E4428C-03A

S E R V I C E N O T E

E4428C Option 506

DC blocking capacitor, from RLC supplier used in above identified serial number units may cause a power drop of approximately 20dBm

**Good part****Defective part**

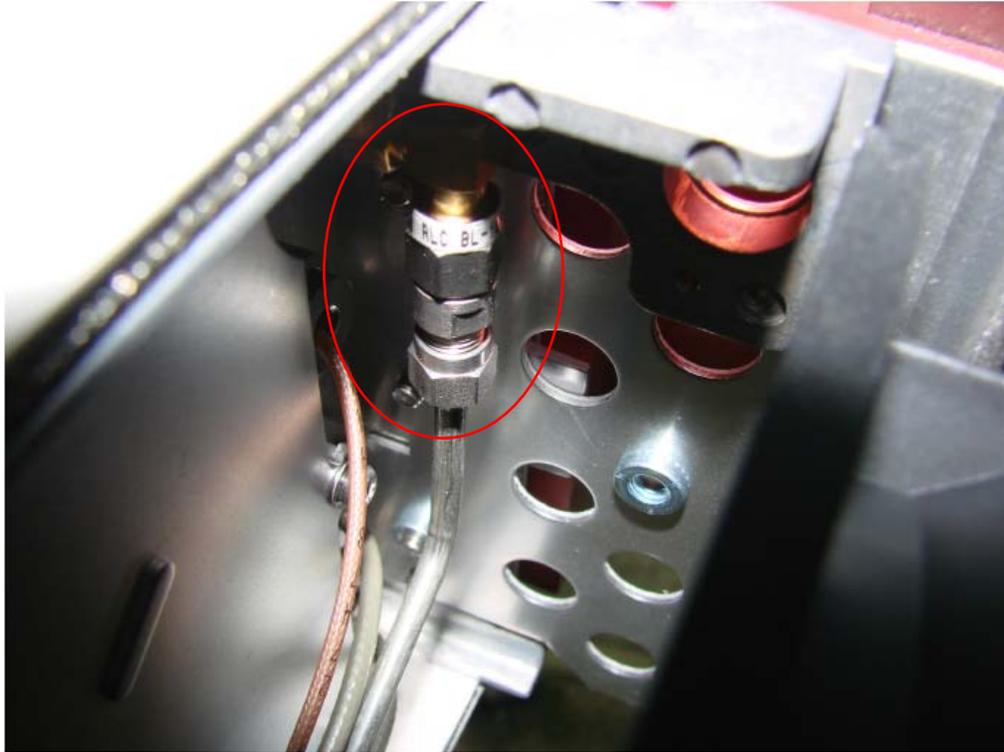
Power drop was observed on the instrument having option 506 and when operating at cold temperature (0 degree Celsius). The failure is caused by the defective DC blocking capacitor where it will show a power loss of approximately 20 dBm at low frequency setting. Repair of the assembly will be covered under warranty.

1. Repair on failure after verification that the defective part is installed inside the instrument.
2. Prevent the failure by repairing the instrument in advance. When the instrument is returned for service or calibration, check the DC blocking capacitor, by looking at the physical part. The good and defective part is shown below:-

3. Location of the DC blocking capacitor and replacement procedure. Refer to the Service Guide, Section 2 Assembly Replacement, A29 DC Blocking Capacitor. Refer to post repair procedures for A29 after replacement of blocking capacitor.

Defective part in the instrument

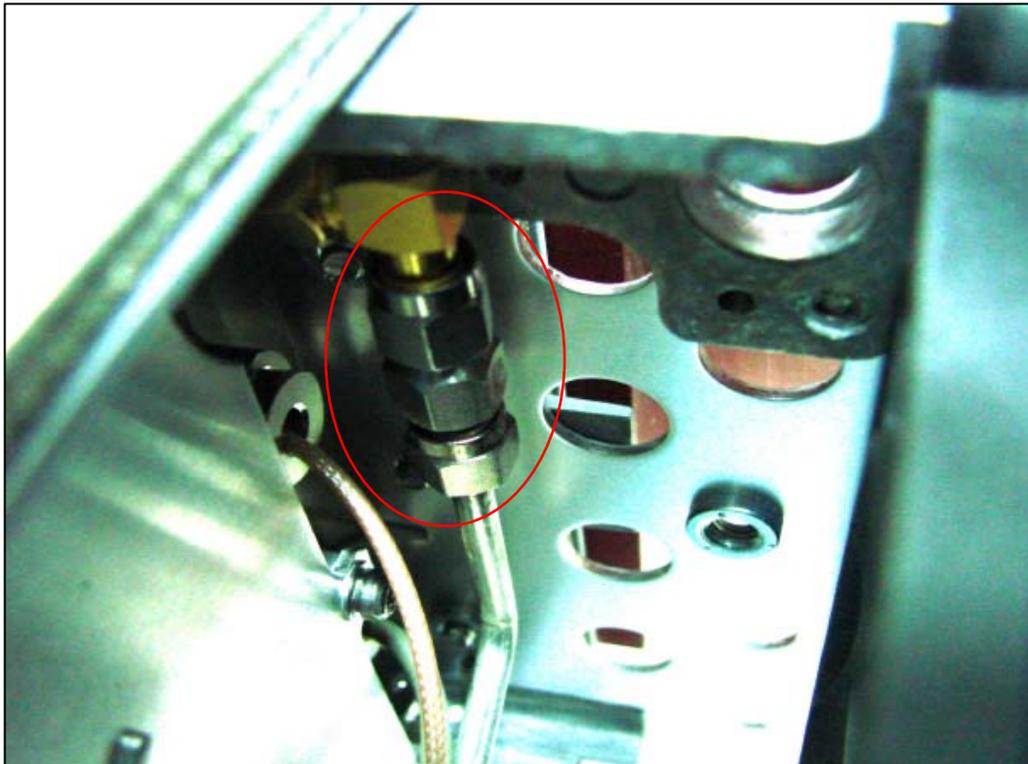
4. Here are the actual photos taken of the DC blocking capacitor in the instrument. As long as you do not break the RF path, by removing the DC blocking capacitor from the instrument, you do not have to perform the post repair procedures of A29 for the instrument having the good DC blocking capacitor.
